ADDENDUM # 1

**To the Town of Westlock's
Request for Proposal
PLAYGROUND FOR ALL - EASTLGEN PLAYGROUND REPLACEMENT**

**Town of Westlock
10003 - 106 Street
Westlock, AB T7P 2K3**

File: DPC70-25

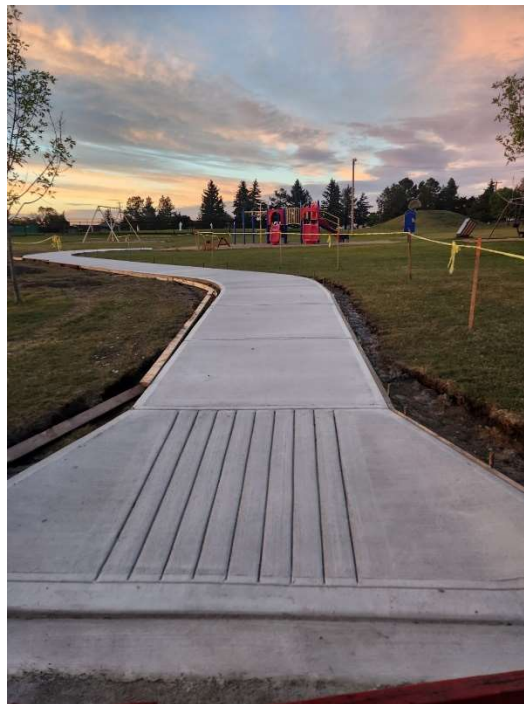
I also had a question regarding the path from the playground to the sidewalk. Is there a preference on material used, and do you have specs you would like us to follow in terms of width/length?

The Town has poured a new concrete path from 103A Street to the proposed location of the park. This path will remain and should be incorporated into your proposal. Picture below for reference.
